Re: Proposed development N70 Waterville to Ballybrack Road Improvement Scheme
Townlands of Waterville, Ballybrack and Eightercua, Co. Kerry

Re: Application of Kerry Council for Consent for Proposed Development (N70 Waterville to Ballybrack Road Improvement Scheme) – Our Clients Eddie Cagney and Ann Roche-Cagney, 6 Benjamin Close, Ballybrack, Waterville, Co. Kerry

PROPOSED N70 WATERVILLE TO BALLYBRACK ROAD IMPROVEMENT SCHEME

Submission made on Behalf of Eddie
Cagney & Ann Roche-Cagney,
6 Benjamin Close, Ballybrack

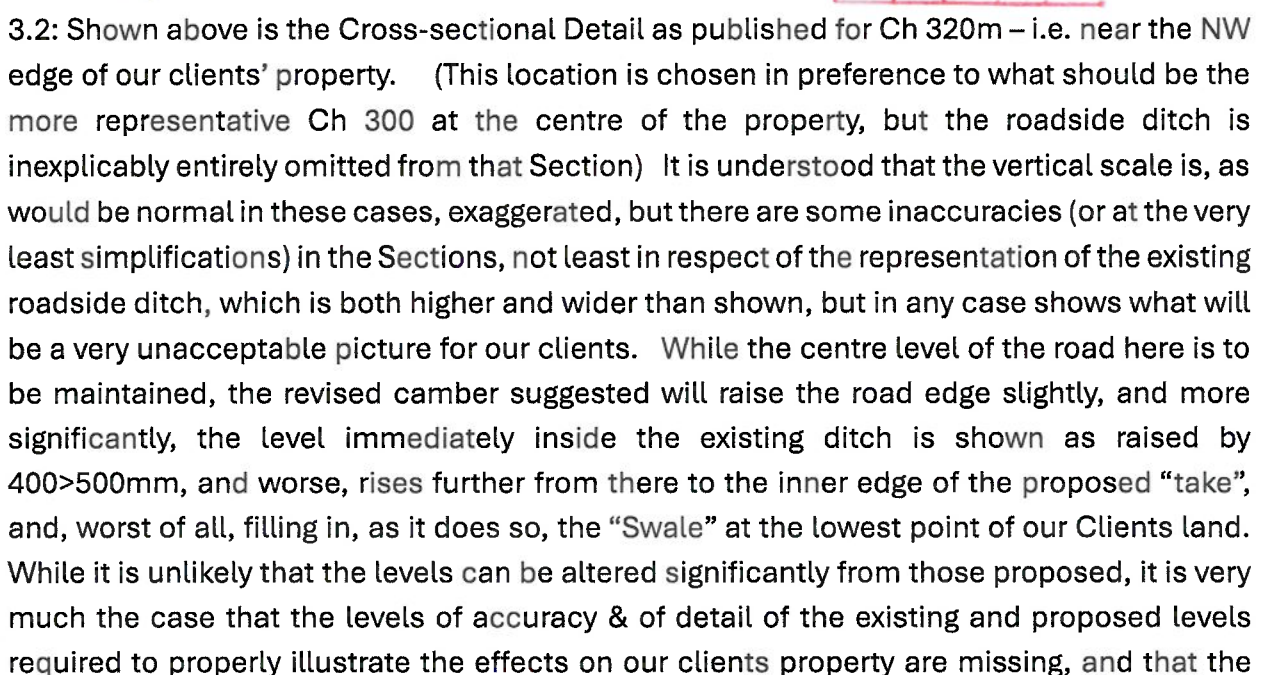
2.1: There will be the obvious (c. 3% or c. 160m²) loss of overall site area, but when the loss of lawn area after allowing for the dwelling itself and the screen planning, the loss of actual lawn area, while numerally still c. 160m², will mean c. 6% reduction in lawn area. It will also “open up” the site to the road, and it will take many years for any “new” screening provided to begin to match the old.

2.2: In addition, there is a distinct lack of clarity and exactness in regard to the precise extent of the “take” suggested –

- the maps are not as definitive as they might seem – the precise computer-drawn lines on the CPO maps are presumably accurate but are, to scale, almost 1 m wide – is the boundary on the inner or outer edges or the centreline of this 1m width? Is the new roadside boundary to be constructed within the “take”? (it would appear that there is insufficient provision for same).

- There is a distinct “twist” shown on the Northern end of the boundary between 130-01 & T130-01 - see enlargement on Right - is it intended that there would be a matching physical Twist?

- It is noted that, measured on the ground, the roadside face to roadside face of our clients’ roadside stone wall/ditch is c. 2.1 m nearer the road than the cut-stone wall fronting his neighbour’s site to the North. However, with a 50m road frontage, a rectangle of 156m² (Area from CPO schedule) would have a depth of c. 3.1m.

- Given the last 2 points, are we correct in assuming that our clients’ lawn would, post works, be shallower than that of the Neighbour to the North?
- As a further complication, the 130-01/130-02 boundary, which on the face of it, should coincide with the existing roadside boundary, has an unexplained kink near the Southern end – see detail on Right. This kink does not exist on the ground, nor is it reflected in either your Engineers’ detailed surveys or the OSI maps. What if anything, is its significance??

- Given all of the above, what would in any case be a not-unreasonable expectation that the proposed land take would be physically pegged now becomes an essential exercise, and we would request that this be done urgently.

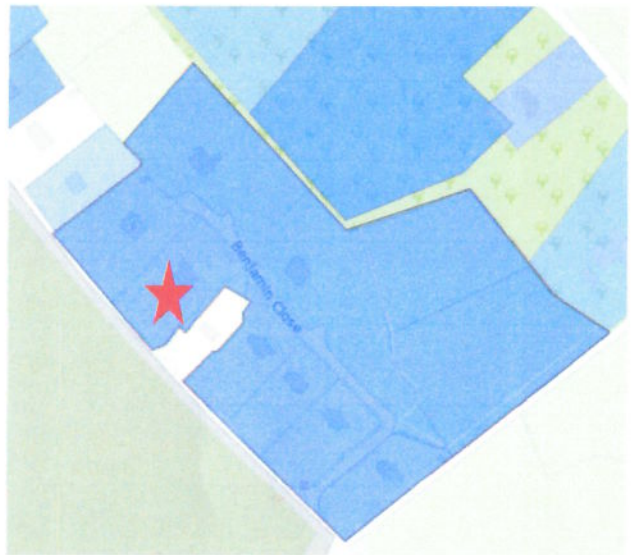
4.1: Our clients' dwelling is one of those in, or at least accessed from, "Benjamin Close" – see extract from Planning Register Map on site with our clients' plot highlighted. Note that all vehicular access to all of them is from the site road, despite 6 of them abutting the N70. The houses were initially built pre-2000, and initially had individual Septic Tanks, one per house. In more recent years, a public sewer was laid on the public road, and the houses adjacent to same, including our clients' dwelling, were connected individually to new sewer.

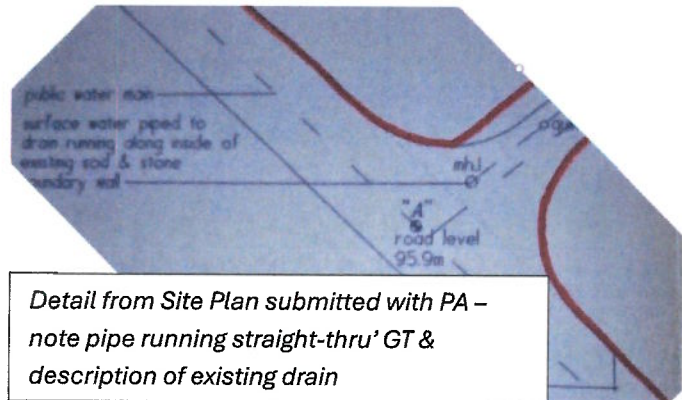
4.3: The Plans on foot of which the initial Planning (485/97) as Granted were, to put it mildly, very basic, even by the standards of the time. The surface water disposal for the individual sites was hardly mentioned, and the road drainage detail, consisted of some GTs connected to a very basic pipe, and discharging linearly one to the other

(with some shown as very basic gulley to gulley “straight-thru’ connections), starting at the Northern (inner) end, eventually discharging at the abutment of the site road with the N70 to what was described as “*drain running along inside of existing sod & stone boundary wall*”. Apart from the pipework arrangement being entirely substandard, and depending on a very effectively non-existent discharge point, this arrangement was patently unworkable on the particular site, as the gradient from what was shown as the highest manhole or gully (outside site 6) was entirely against the natural slope, with, were it to be installed as shown, a dig of up to 7m thru solid rock being required!! (The Road Level at G3 is c. 7m higher than at G5) (see Plan on Right).

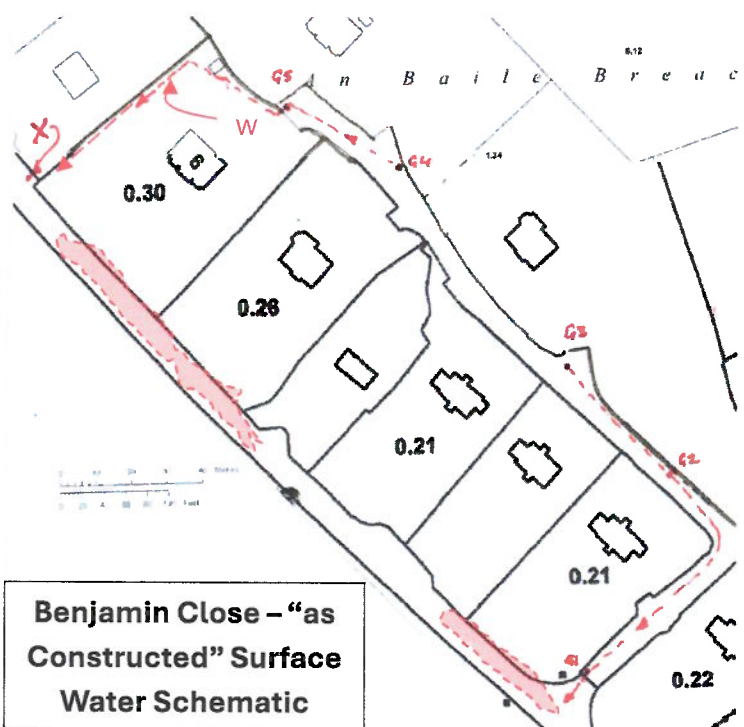
4.4: What was actually installed was two separate SW systems, both substandard & both discharging to the same non-existent drain – an outline of this arrangement, involving some assumptions/guesses, but easily accurate enough to illustrate the principles is shown on right. It shows 5 Gullies in total, 3 discharging towards the entrance, starting from G3 at the high point, and G4 & G5 discharging along our clients’ North-Western boundary via a recently partially-discovered pipe, but eventually reaching the roadside boundary thru’ a combination of pipes, stone drains and surface flow. In reality, as all the Gullies bar G5 are located on the highest side of a one-way camber, the Gullies are ineffective, and all of the water discharges onto to the original public road near

G1, or into our clients' site via G5 or the grating across their entrance (Pictured Left) which they installed themselves 3 to 4 years ago in an effort to protect their site, but which proved largely ineffective – it does "catch" some water, but this merely then flows into the same onsite network that it would eventually have reached anyway, and so in any case ends up at the North Western corner of their site. The "Bottom line" is that in even moderate rain, water ponds along the roadside boundary of their lawn, which is the lowest point, creating an unintended swale or sump of sorts which runs along the joint road frontage, but which most particularly affects our clients

and their immediate neighbours to the South East, as these two houses are, given the general Northward slope, the lowest of the lawns, and the position is further exacerbated by the fact that the level of the lawn of No. 6 is up to 500mm under the existing public road level.

(It does appear that there may have been some intention that the pipe installed along their North-Western boundary may have been intended to reach an adjacent pipe at Point "X" on the plan on the previous page, but that pipe is, firstly, effectively level with the pipe at point "W" on the same Plan, but also is of dubious capacity in itself - there is an exposed "Corripipe" drain here with the end visible down a rudimentary, and probably accidental, hole – see photo on Right showing tape projecting into hole.

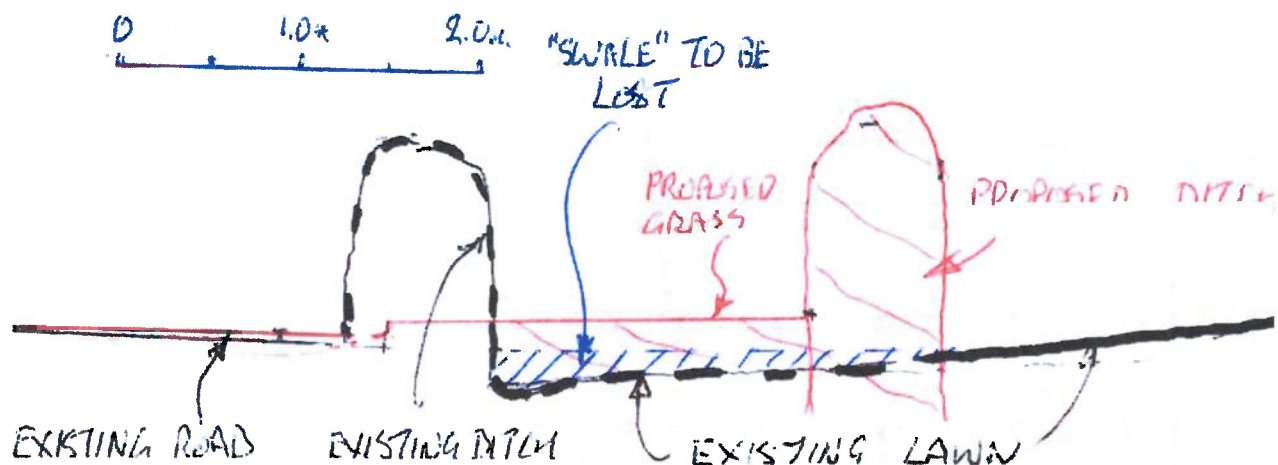
It appears that this pipe was laid as part of the Roadside setback works for the adjacent site, but it is entirely unclear what discharges to it, or where it discharges to, or even what direction it flows in (it probably falls with the road towards Waterville), but there is no confirmation of this). In addition, the pipe base is only c. 650 under road level, and, as already noted, at best level with the pipe supposedly flowing to it from Point "W" It also appears to be surrounded by less-than-ideal bedding & haunching. All in all, and for whatever reason, is it not taking any water, and instead the water "wells up" to spread along the unintended swale.
